Groundwater Transfer Review Summary Form

Transfer/PA # T- <u>14267</u>					
GW Reviewer J. Hootsmans/J. Hackett Date Review Completed: _11/3/2023_					
Summary of Same Source Review:					
\Box The proposed change in point of appropriation is not within the same aquifer as per OAR 690-380-2110(2).					
Summary of Injury Review:					
☐ The proposed transfer will result in another, existing water right not receiving previously available water to which it is legally entitled or result in significant interference with a surface water source as pe 690-380-0100(3).					
Summary of GW-SW Transfer Similarity Review:					
$\hfill\Box$ The proposed SW-GW transfer doesn't meet the definition of "similarly" as per OAR 690-380-2130.					
This is only a summary. Documentation is attached and should be read thoroughly to understand the

1.	Basic description of the changes proposed in this transfer: The applicant proposes to add an additional Point of Appropriation (POA), UMAT 6433 (Sand Hollow Well), to the three Certificates currently irrigated by authorized POA UMAT 1435 (Morrison Well). The affected certificates are Certs 40919, 40920 and 46354.

Cross Section: POA to POA

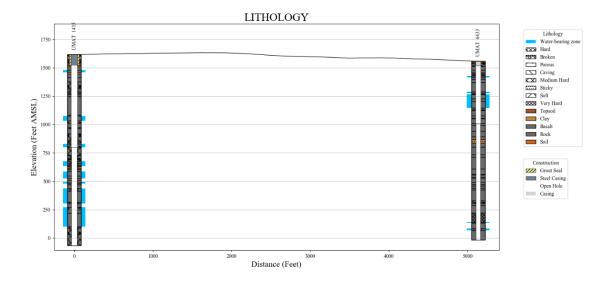
- 2. Will the proposed POA develop the same aqui ☐ No Comments: The authorized produces from multiple water-bearing zones (WBZs) in the Columbia River Basalt Group (CRBG) aquifer system. The proposed POA (UMAT 6433) is 1575 feet deep and also produces from multiple WBZs in the CRBG aguifer system. Additionally, water level elevations in both POAs are between 1450 and 1500 feet above mean sea level (amsl). All these factors indicate the POAs produce from the same aguifer.
- 3. a) Is there more than one source developed under the right (e.g., basalt and alluvium)? ☐ Yes No Both the Authorized POA and Proposed POA develop water from the CRBG aquifer system.
 - b) If yes, estimate the portion of the right supplied by each of the sources and describe any limitations that will need to be placed on the proposed change (rate, duty, etc.):
